### 3.5 Missile Protection

The information in this section of the reference ABWR DCD, including all subsections, tables, and figures, is incorporated by reference with following departure and supplements.

STP DEP 3.5-1 (Table 3.5-1 and Figure 3.5-2)

Figure 3.5-2 Low-Trajectory Turbine Missile Ejection Zone

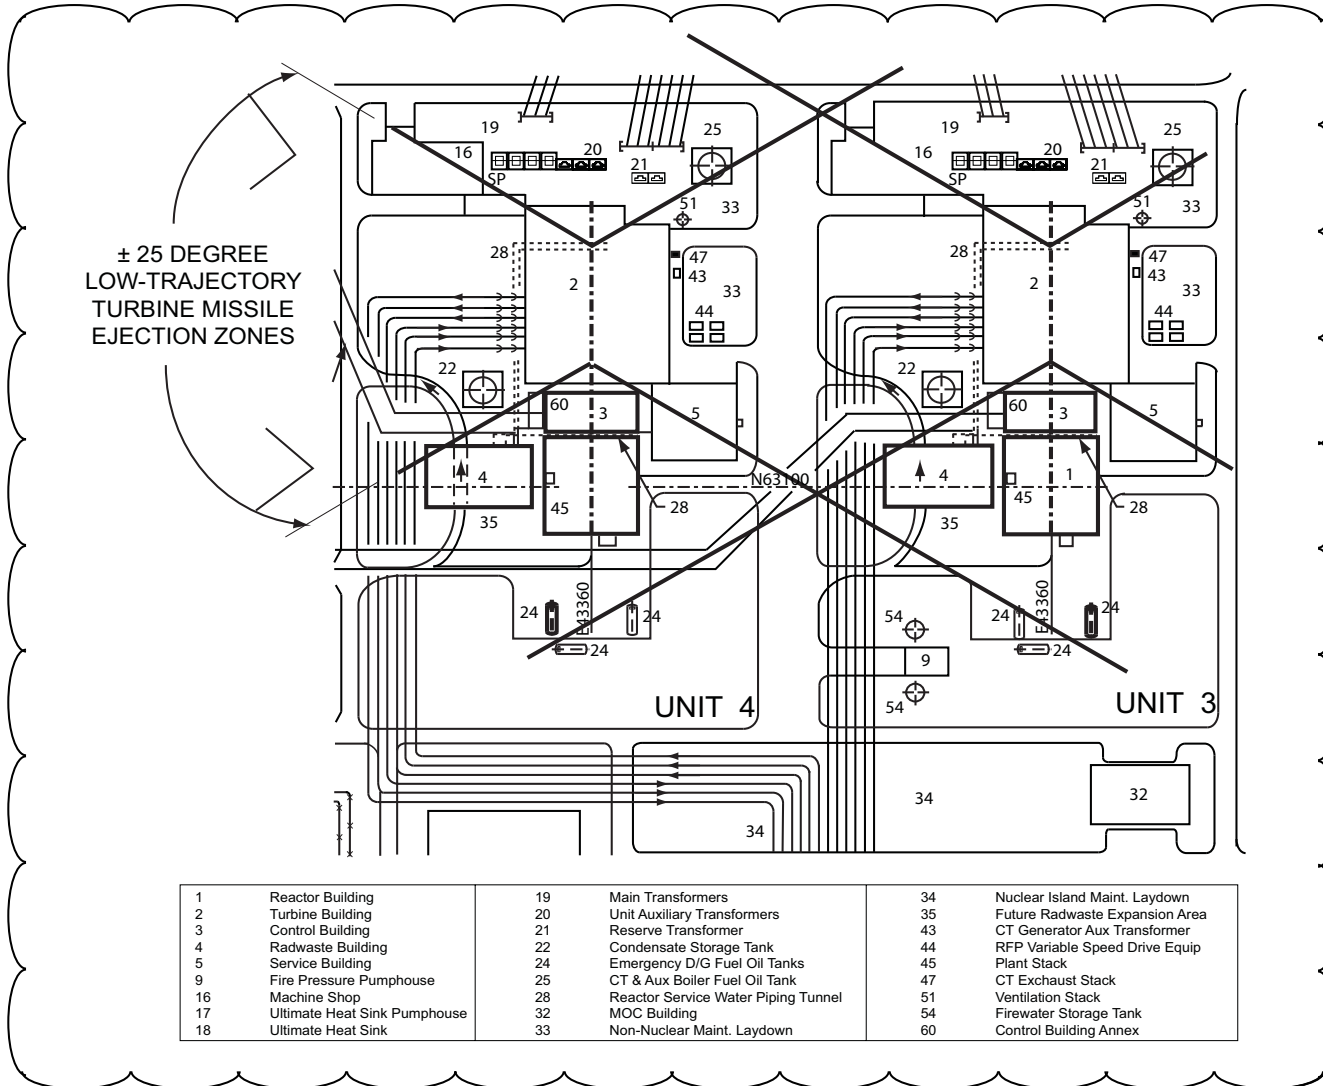
STP DEP 3.5-1

~~Acceptance Criteria 1 of SRP Section 3.5.1.3 considers a plant with a favorable turbine generator placement and orientation and adhering to the guidelines of Regulatory Guide 1.115 adequately protected against turbine missile hazards. Further, this criterion specifies that exclusions of safety-related structures, systems or components from low trajectory turbine missile strike zones constitutes adequate protection against low trajectory turbine missiles. The turbine generator placement and orientation of the ABWR Standard Plant meets the guidelines of Regulatory Guide 1.115 as illustrated in Figure 3.5-2.~~

The STP 3 & 4 turbine generator placement and orientation in relation to essential systems of the adjoining unit are illustrated on Figure 3.5-2. Per Regulatory Guide 1.115, the STP 3 & 4 turbine generator placement and orientation is considered unfavorable. Per Acceptance Criteria 1 of Standard Review Plan Section 3.5.1.3 for unfavorable turbine generators, a value of  $10^{-2}$  per year per plant was chosen as a conservative value for the product of strike probability ( $P_2$ ) and damage probability ( $P_3$ ). The criteria for unfavorable turbine generator orientation given in Standard Review Plan Table 3.5.1.3-1 and provided in Table 3.5-1 was assumed for the missile generation probability ( $P_1$ ). The resulting probability of unacceptable damage from a main steam turbine missile ( $P_4$ ), which is  $P_1 \times P_2 \times P_3$ , is less than  $10^{-7}$  per year per plant.

Therefore STP 3 & 4 main steam turbine generator placement and orientation meets the acceptance criteria of Standard Review Plan 3.5.1.3 and the guidelines of Regulatory Guide 1.115.
